**HAINES BOROUGH
HAINES STREET IMPROVEMENTS PHASE II**

ADDENDUM TO THE CONTRACT

Addendum No: 1

July 14, 2011

**WILLARD STREET
2ND AVE. TO 1ST AVENUE**

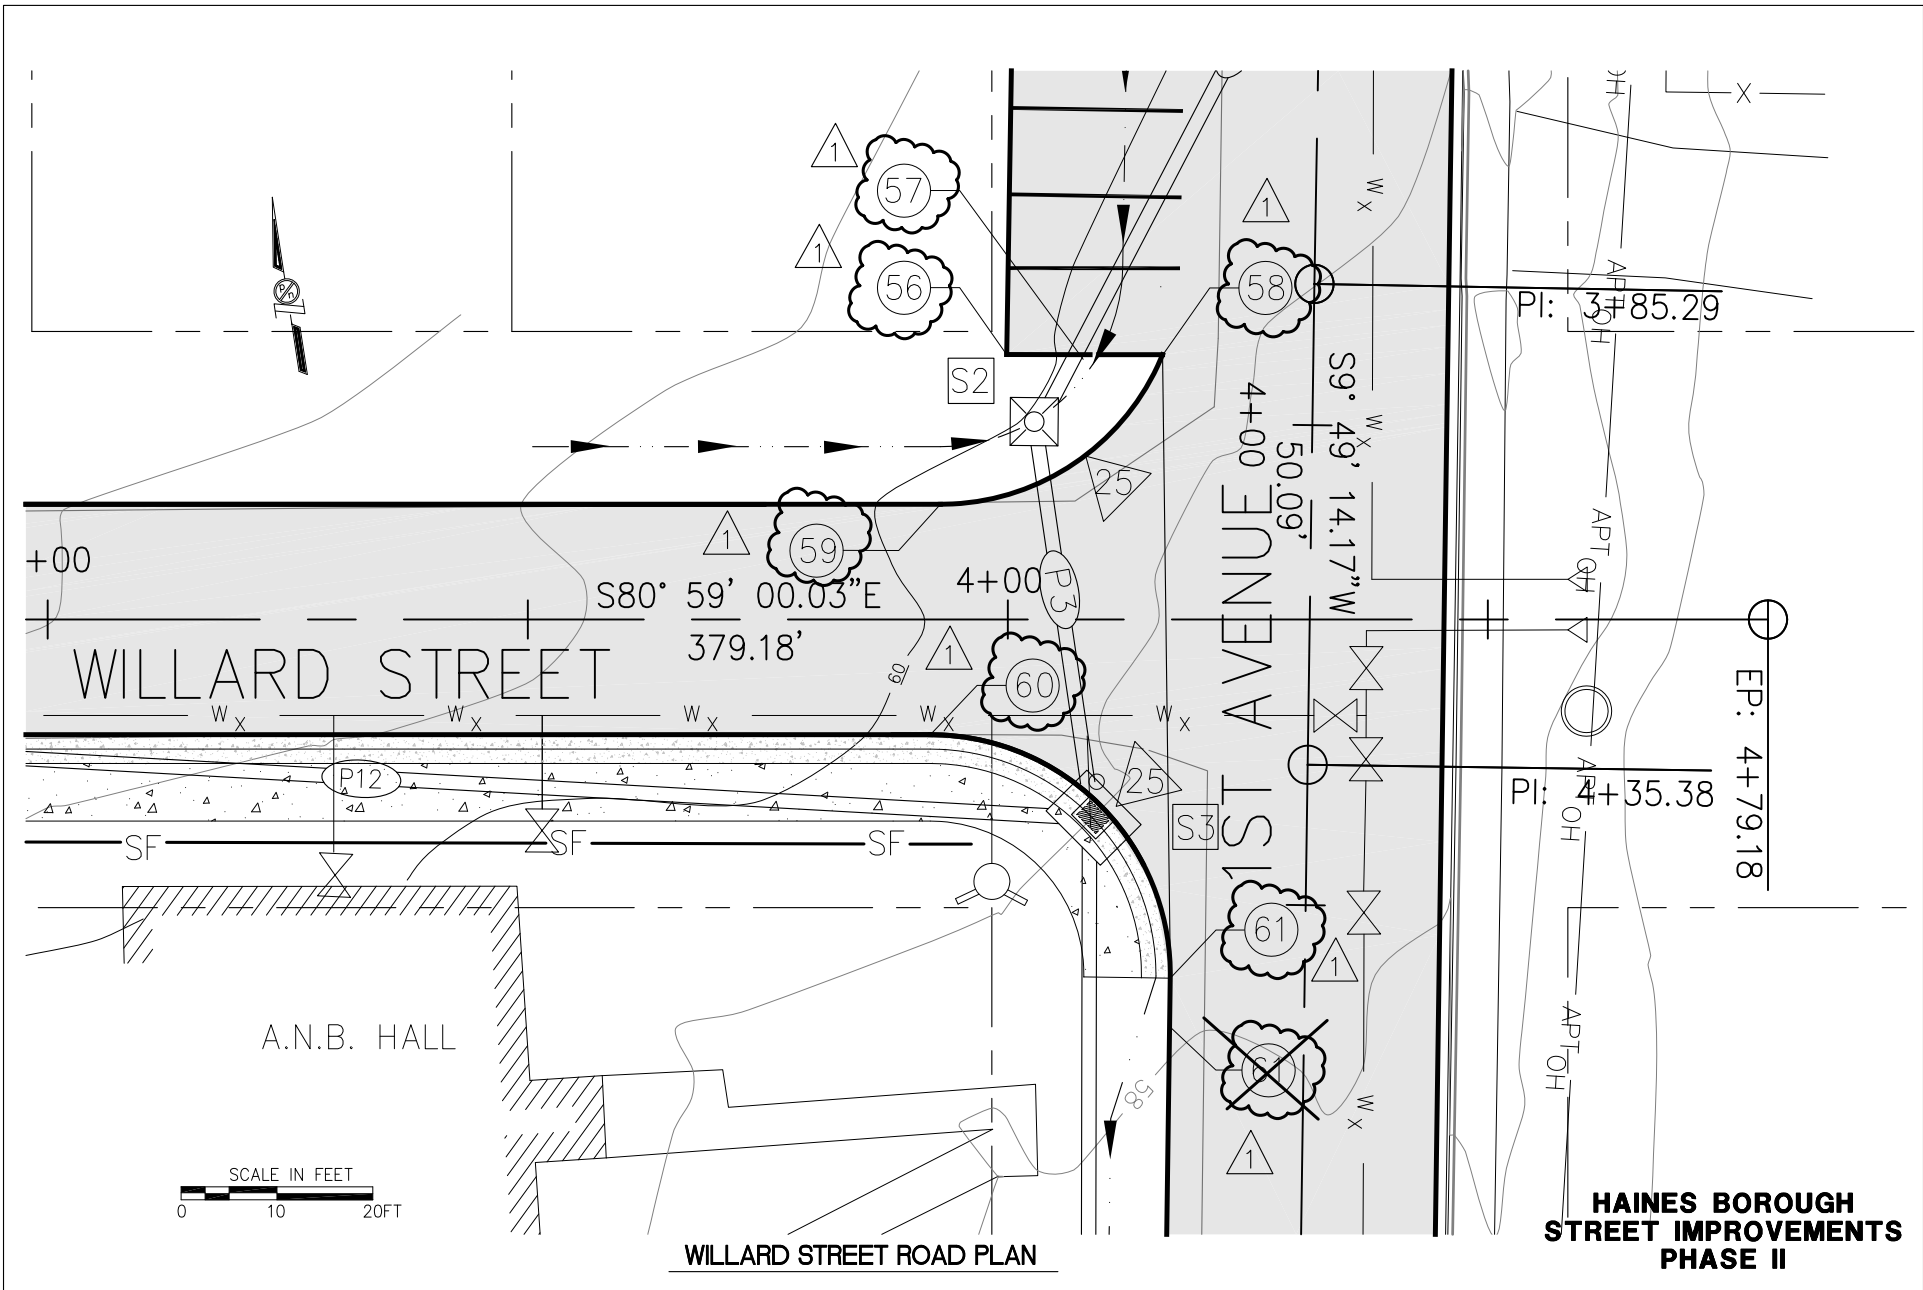
13. Drawing Sheet H1, 17 of 19, Willard Street, 2nd Ave. to 1st Ave: Road Layout Points have been renumbered to match all other sheets. See attachment. Refer to Drawing Sheet C2, 4 of 19, Summary Tables for all point locations and descriptions.

REV.	DATE	DESCRIPTION	DWN.	CKD.	APP.
1	7/14/11	RENUMBER LAYOUT POINTS TO MATCH ALL SHEETS
